Technical Memorandum

Project : MFG East Grinstead, 147-149 London Road
Date : 1 April 2025
Ref : EC18447-8
Author : Jon Mudd BEng(Hons) MIOA

TITLE : Additional Commentary on Potential Noise Impact from Deliveries to MFG East Grinstead

Figure 1: Illustration of Booker delivery and unloading

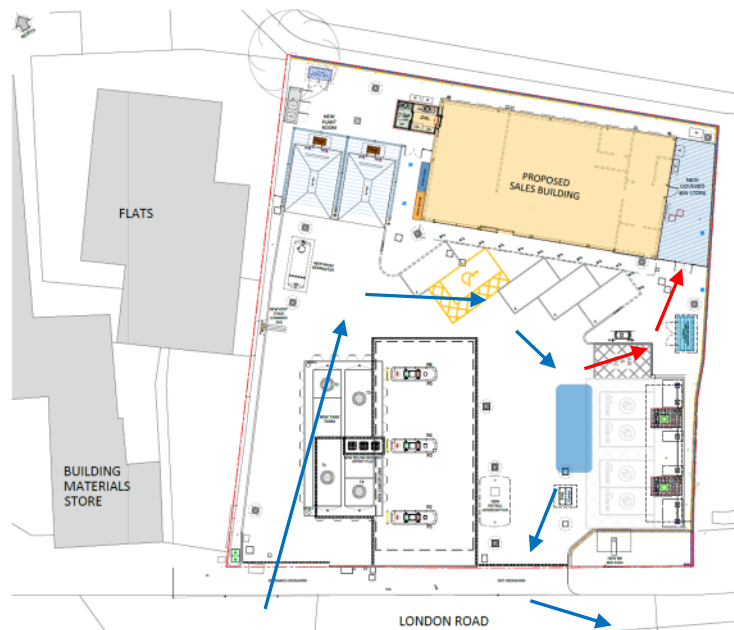
Given that the expected deliveries and collections are likely to include lorry engine noise, refrigeration unit noise, reversing beepers, tailgate noise, lorry door slams, cages being moved, bin emptying etc, it is not clear how the report can justify only using a 3dB intermittency penalty for all deliveries. The adjacent Parkview House overlooks the site so the sounds identified above are likely to be clearly perceptible during the evening period that is relevant for this variation.'

Stock cages are manoeuvred onto the tail lift, with a maximum of two cages at a time. The ramp on the unloading side is lowered slowly to ground level as the tail lift is lowered, generating negligible noise against the background levels. There are no significant impacts or impulsive noise levels associated with the tail lift operation.

While our library data assumed vinyl-wheeled stock cages, all Booker delivery cages observed on-site had rubberized wheels, significantly reducing rolling noise. Some rattling from the cages was noted.

The witnessed delivery involved unloading four cages into the covered bin store, followed by the loading of four empty cages back onto the lorry, requiring four tail lift operations. The refrigeration unit beneath the trailer remained off throughout the visit. The entire delivery process took 24 minutes.

Noise level measurements indicate that the resultant noise level is 5dB lower than previously used in our BS4142 assessment. A worst-case +3dB correction under BS4142 remains appropriate, as intermittent noise from stock cages would be barely perceptible at Parkview House with the ambient noise levels across the proposed delivery window of 0700-2300hrs consistently remaining above 55dB(A) L_{eq} .
